MCQN-80 (3-1/4")
CB, CB2 Part Appearance Optimization,
screw length Change Notification

MCQN - Ø80 (3-1/4") CB 、CB2

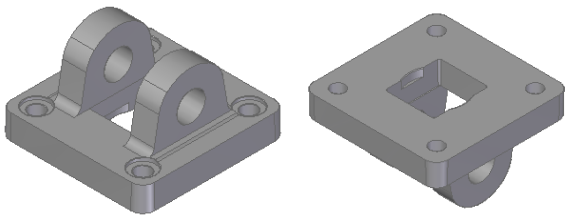
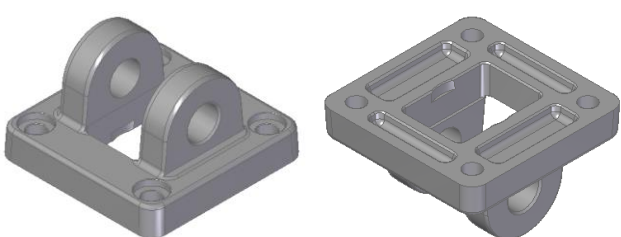
1. CB : Optimise shape, reduced weight.

2. CB 、CB2 : Change the depth of the counterbore and the length of the bolt to ensure lock function.

Before		After	
CB		CB

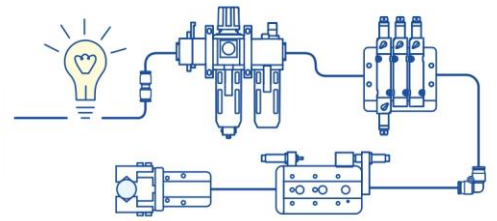
1. CB : Optimise the shape.
